Access Compliance Report

Public Rights-of-Way

Intersection ID: 9807	Main Street: TINNIN_AV	Cross Street: DOUBLE_OAKS_RD	Location: SW
ADA ID: AC3665A18E91	Ramp Type: PerpDiag	Initial Pass/Fail: Fail	Overall Compliance: No
			Severity Score: 21.25

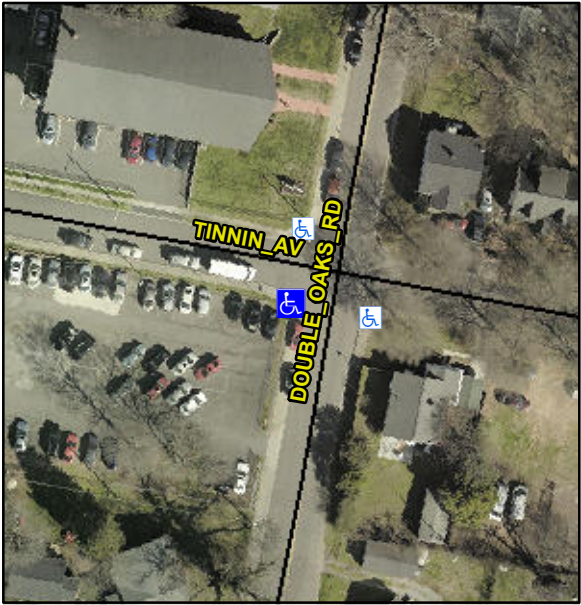
Codes/Mitigation Info/Possible Solution		Field Measurements/Component Compliance			
	Possible Solutions:				
	Remove & Replace Curb Ramp With Two New Directional Ramps or Equivalent.				
	Surveyor Notes:				
	N/A				
	PROW/ADA:				
	R304.5.1, R304.2.2				
Street 1 Name	DOUBLE OAKS RD				
Stop Condition-Street 2	None				
Street 2 Name	TINNIN AV				
Stop Condition-Street 1	StopSign				
Total Cost:		\$	3200.00

Compliance	Description	Data	Compliance	Description	Data
N/A	Ramp Length (in)	65.5	No	Ramp Slope (%)	10.3
No	Ramp Width (in)	42.5	Yes	Ramp XSlope (%)	1.4
N/A	Flare Type LT	N/A	N/A	Flare Type RT	N/A
N/A	Flare Slope LT (%)	N/A	N/A	Flare Slope RT (%)	N/A
N/A	Flare Traversable LT?	N/A	N/A	Flare Traversable RT?	N/A
N/A	Landing Length (in)	N/A	N/A	DWS Provided?	N/A
N/A	Landing Width (in)	N/A	N/A	DWS Contrast?	N/A
N/A	Landing Slope (%)	N/A	N/A	DWS Length (in)	N/A
N/A	Landing X Slope (%)	N/A	N/A	DWS Full Width?	N/A
N/A	Landing Curb? (Y/N)	N/A	N/A	DWS Offset (in)	N/A
N/A	Shared Landing?	N/A			
N/A	Gutter Ponding?	N/A	N/A	Gutter Slope (%)	N/A
N/A	Gutter Lip Ht (in)	N/A	N/A	Gutter X Slope (%)	N/A
N/A	Painted X Walk1?	No	N/A	Painted X Walk2?	No
	X Walk 1 Direction	To SE		X Walk 2 Direction	To N
N/A	X Walk 1 Width (in)	N/A	N/A	X Walk 2 Width (in)	N/A
	X Walk 1 Slope (%)	6.6		X Walk 2 Slope (%)	3.3
	X Walk 1 X Slope (%)	2.7		X Walk 2 X Slope (%)	4.4
